PLAN COMMISSION/HISTORIC PRESERVATION COMMISSION WEDNESDAY, APRIL 22, 2020

From: [Robert Wright](#)
To: cdi@chorus.net; [Nic Owen](#); [Kathy Hagen](#)
Cc: [Mike Slavney](#); [Michael Rochon](#)
Subject: RE: Updated Preliminary and Final Plats for Sixth Addition to Kara View Heights
Date: Monday, April 20, 2020 9:16:15 AM

To: Village of Mount Horeb Plan Commission
From: Village Planner Michael A. Slavney, FAICP
Date: April 22, 2020
Re: Village Planner's Preliminary Site Plan and Design Review Comments for Proposed Casey's Convenience Store, Gas Station, and Car Wash for April Plan Commission

LAYOUT PLAN

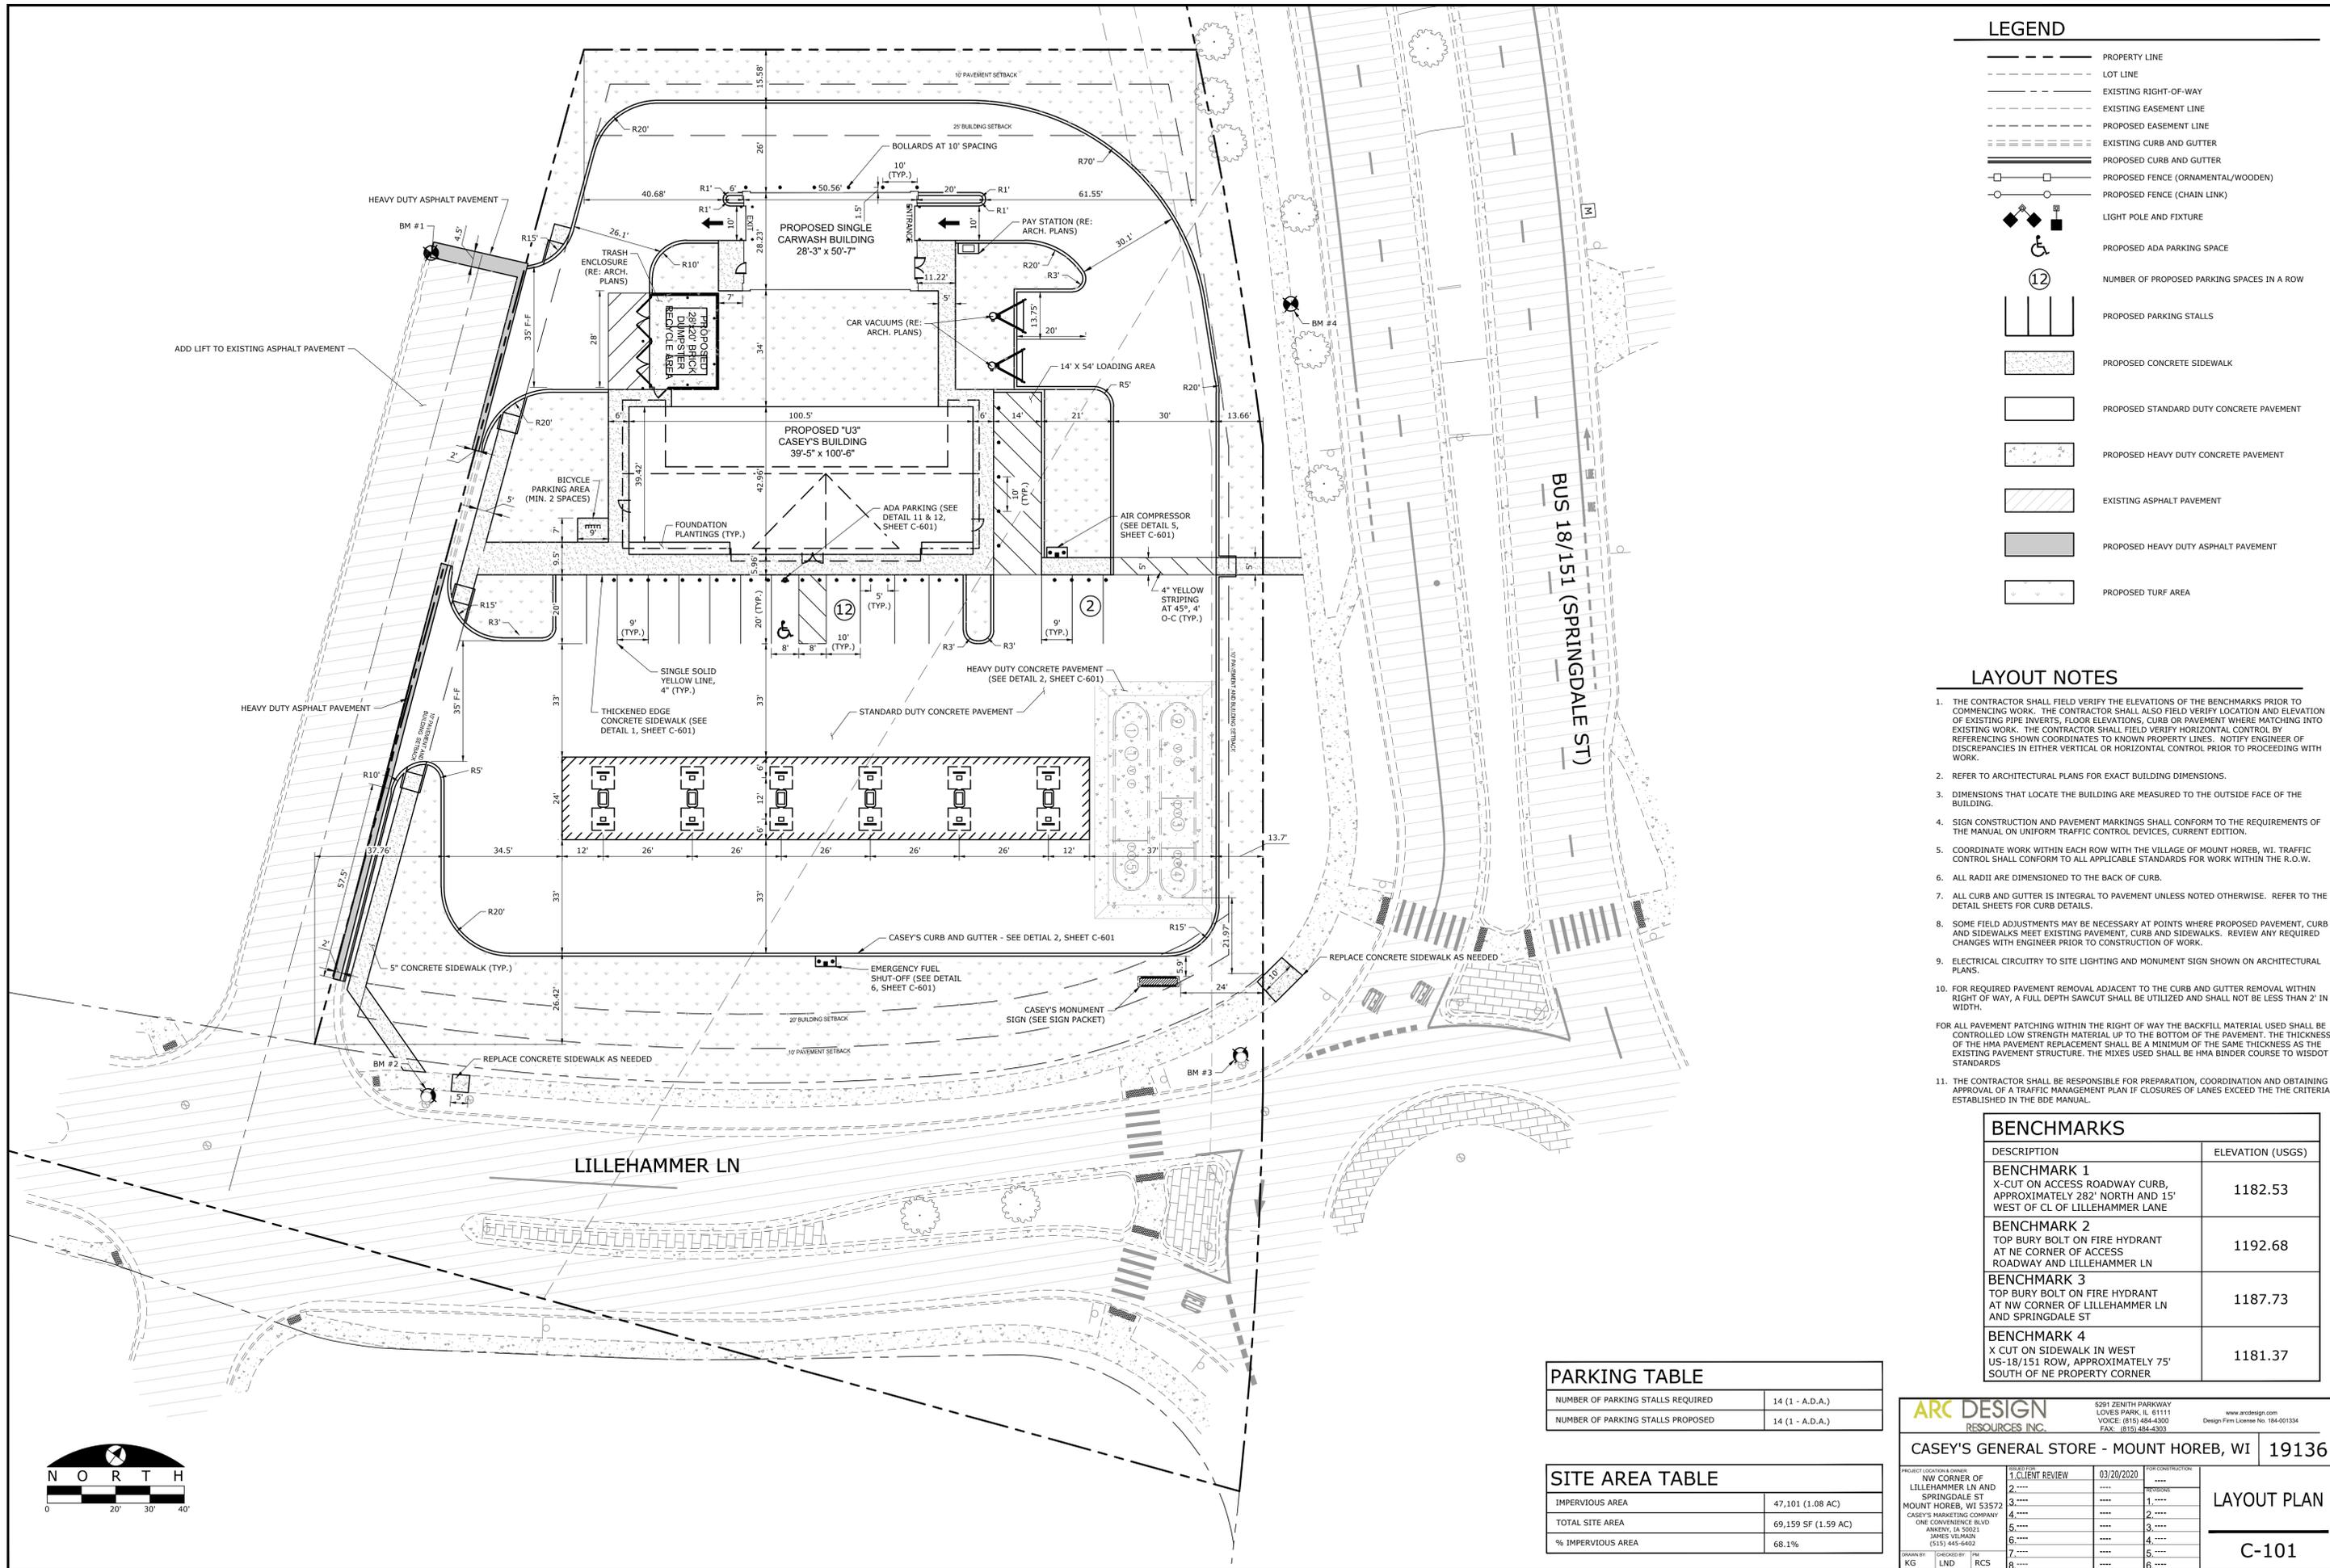
- This is a challenging site, with two public street frontages, the site approach from a private drive, and the buildings highly visible when approaching on Springdale Street from the west. The development plan proposes the building facing east – toward US 151 and Lillehammer Lane, which results in the building side facing Springdale Street and the building rear facing west down the length of Springdale Street. The building elevations and landscaping plan have been upgraded to address this challenge. The Plan Commission should discuss whether the proposed building orientation and appearance results in an acceptable alternative to having the building face Springdale Street – which results in the sides facing east to Lillehammer and USH 151 and to west, with the rear facing the private drive serving the site entrance and exit.

- a. Traffic circulation patterns shall be safe and understandable by vehicle operators, as determined by the Plan Commission.
 - This requirement is met, including the minimum 25-foot deep entry before encountering a vehicle exiting a parking space.

- This standard is not met due to the need to access the car wash, and to route fuel delivery vehicles around the site. Does the Plan Commission wish to consider an exception for this requirement?

- a. A minimum 10-foot wide landscaping bed or planter shall be provided along at least 50% of each wall facing a street, drive or parking area, except within the downtown area.
 - This requirement is not quite met on the front façade, where the planter beds abut about 46% of the east wall. Given the food prepared and available inside, I feel an exception to allow as depicted would be appropriate. Does the Plan Commission wish to consider an exception to this requirement?
- b. This bed or planter shall be located adjacent to or within 10 feet of the building foundation.
 - This requirement is met.
- c. This bed or planter shall be landscaped appropriately as determined by the Plan Commission.
 - Unknown at this time. Will be provided in the public hearing packet.
